Mather Air Force Base

Second Five-Year Review of Remedial Actions

September 24, 2004

Subject: Second Five-Year Review of Remedial Actions at Mather Air Force Base, California

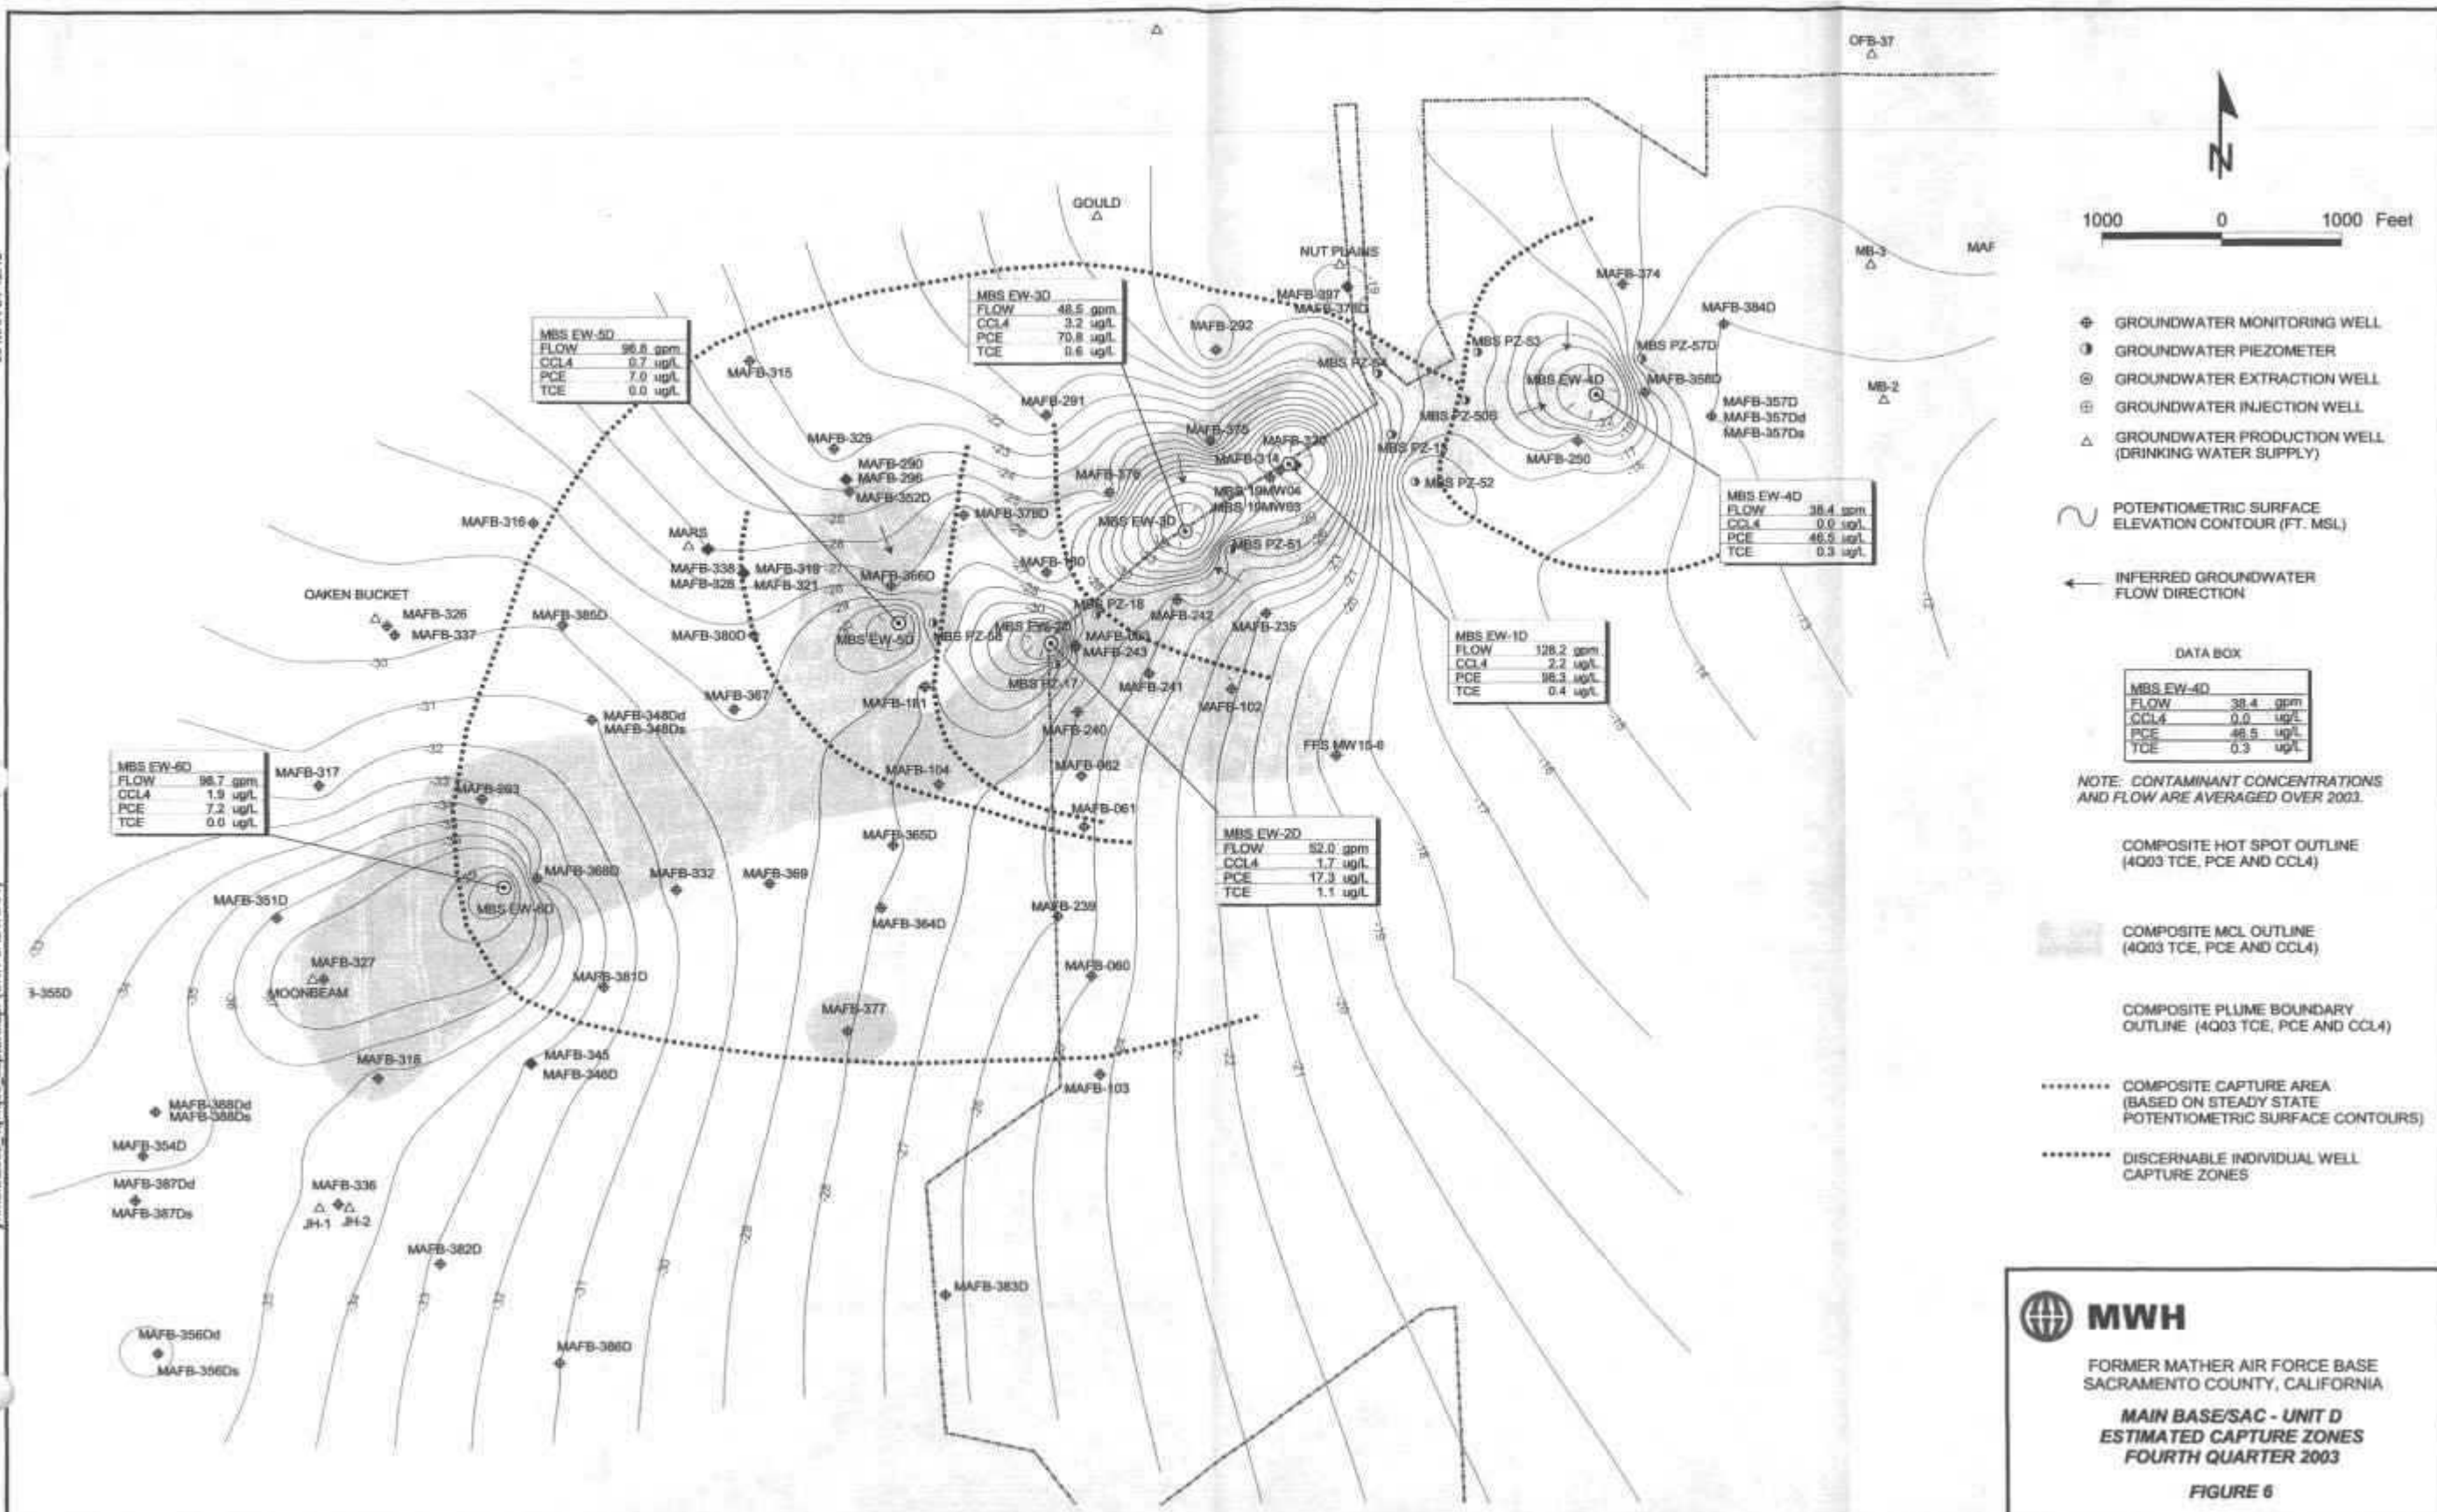
b. Recommend depicting and labeling this plume on Figure 2.

U.S. EPA 4. The known extent of groundwater contamination shown on Figure 2 is eight years out of date. The Report should include additional figures illustrating the extent of groundwater contamination as it is currently known to exist, the locations of extraction and injection wells, estimated or measured capture zones for the extraction systems, the general groundwater flow direction, and the location of vadose zone sites and soil vapor extraction (SVE) systems relative to the known extent of groundwater contamination. A comparison of changes in groundwater plume configurations over time would also greatly enhance the discussions of the progress since the last review.

Comment Response: In response to (a), the text has been changed as suggested. In response to (b), Figure 2 has been replaced with more up to date maps that include the 7100 Area (Site WP-07) Plume.

Comment response: Figure 2 has been replaced with up-to-date figures showing most information as requested, as well as references to other figures in the most up-to-date source documents. A comparison of changes in groundwater plume configurations over time is available on figures 6-2 through 6-4 of the draft 2003 annual groundwater monitoring report (MWH, 2004) and these figures have been referenced in the text.
